**CITY OF CARMEL-BY-THE-SEA
PLANNING COMMISSION
REGULAR MEETING AGENDA**

January 13, 2016
Wednesday
Tour: 3:00 p.m.
Meeting: 4:00 p.m.

Planning Commission Report

Planning Commission Report

Proposed Exterior Lighting

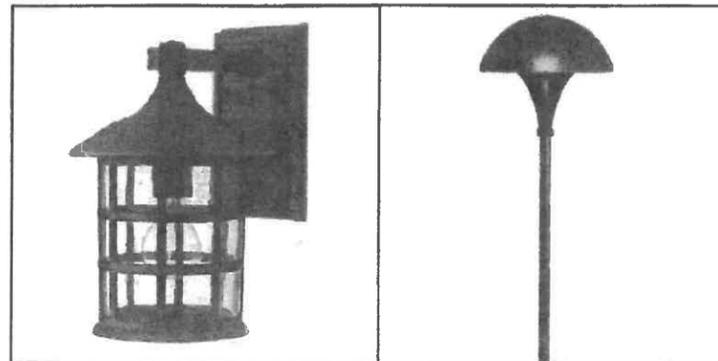
The applicant is proposing two styles of lights: wall-mounted Hinkley 1804 Dark Sky lights and Hinkley H56000 landscape lighting. Lighting Details are included on sheet D4 of the plans. The wall-mounted lights are proposed to be located in 5 locations: on either side of the garage, at the front entry, and two in the front courtyard. Staff notes that the wall-mounted lights are lantern style, and the Planning Commission has previously encourage down-lit lights instead of the lantern-style to be more in conformance with the Residential Design guidelines. A condition has been drafted requiring the applicant to work with staff on an appropriate down-lit fixture.

22.	The three bathroom windows along the east elevation shall contain only obscure glass, as noted on the plans.	✓
23.	The applicant shall work with staff on proposing an alternative type of down-lit light fixture prior to applying for the building permit.	✓

Proposed ELEVATIONS

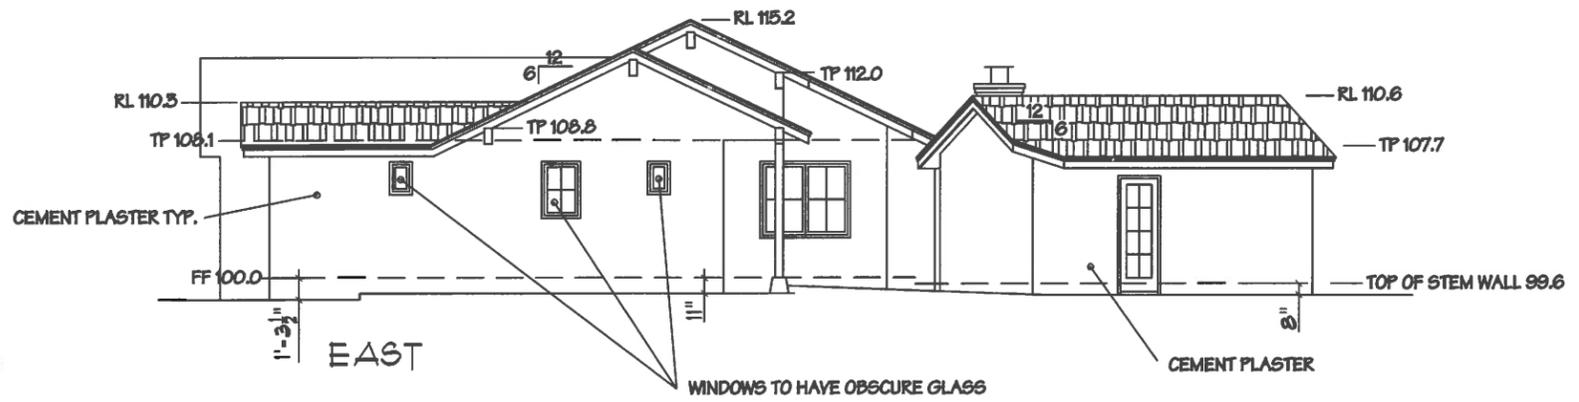
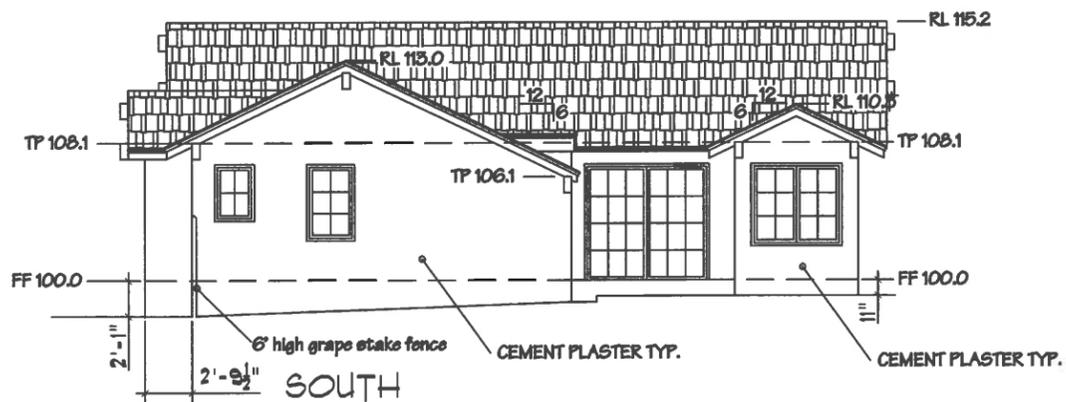
Analysis: The applicant had originally proposed stone veneer on the West elevation and stucco siding on all other sides. The Commission had concerns with the contrast of the two materials and directed the applicant to revise the exterior materials to create more consistency throughout all elevations. The applicant has revised the finish materials and is now proposing stucco siding on all elevations. Residential Design Guideline 9.5 encourages the use of “natural building materials” and states that “stucco, in conjunction with some natural materials, may be considered depending on neighborhood character.” With regard to neighboring properties, the adjacent residence to the west has stucco siding and the adjacent residence to the south has horizontal wood siding.

Analysis: In order to reduce privacy impacts to the adjacent east neighbor, the Planning Commission recommended that the three small windows along the east elevation have opaque or frosted glass. The applicant has revised the plans as noted on Sheet D7 of the plan set to incorporate obscure glass on all three windows. Staff has included a condition that these windows contain only obscure glass, as noted on the plans.

LIGHTING PLAN
1/8" = 1'-0"

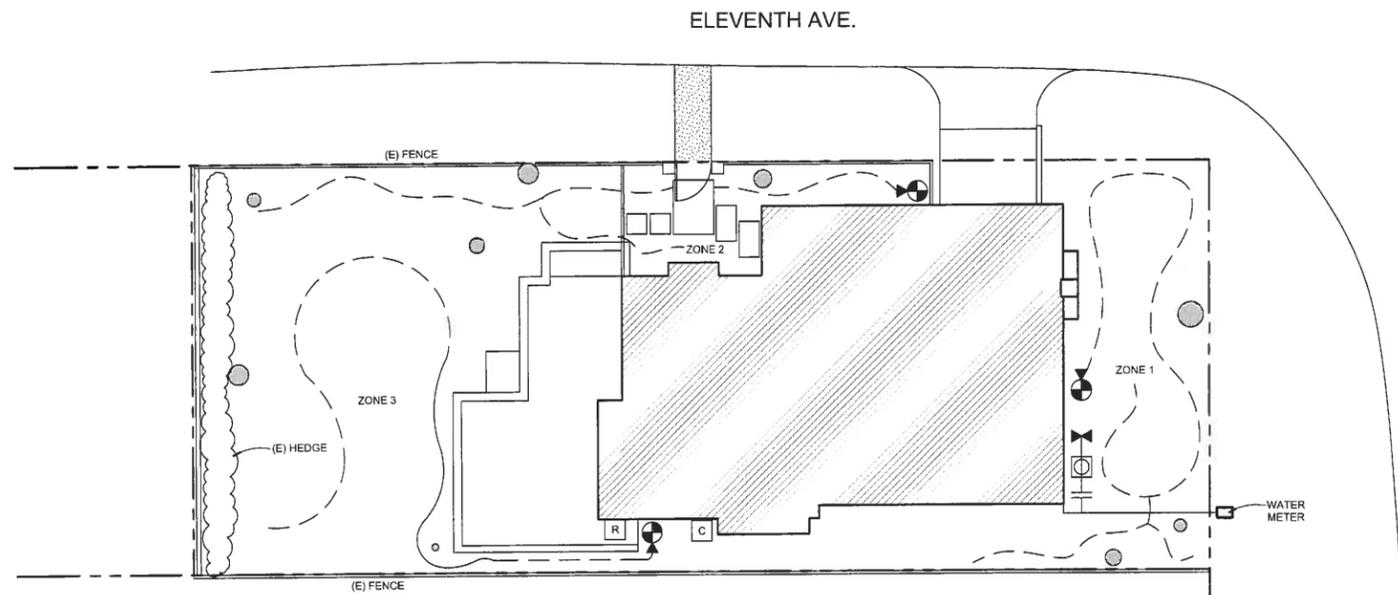
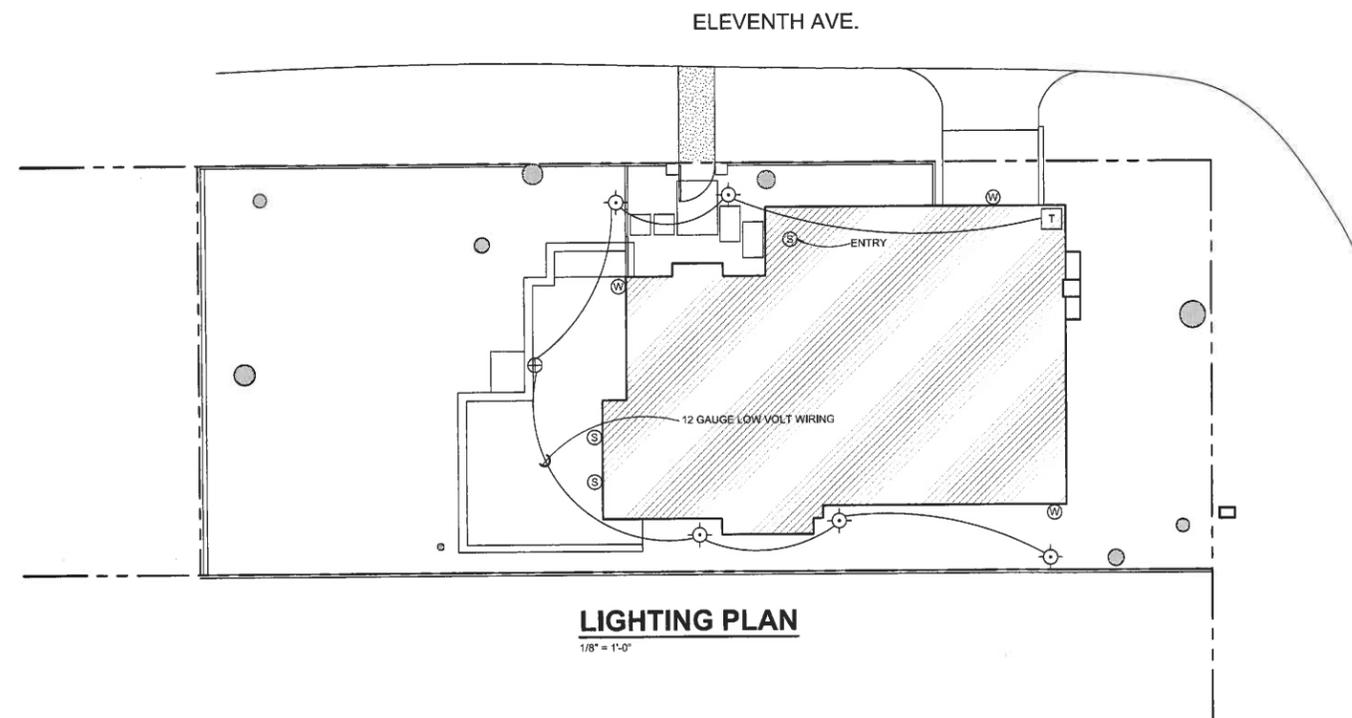
Exterior Lighting: With regard to light fixtures, Municipal Code Section 15.36.070.B.1 requires that exterior light fixtures on the building not exceed 25 watts (incandescent equivalent; i.e., approximately 375 lumens) or 10 feet in height. The locations of the proposed light fixtures are depicted on the elevations included on Sheet 6 of the plan set, and the details are included on sheet L2. The applicant is proposing two different light fixtures: one is a Kichler brand incandescent light fixture with an output of 25 watts and the other is a WAC Lighting brand LED light fixture containing three 3-watt LED bulbs that will be dimmed to 10% with an electronic low voltage (ELV)
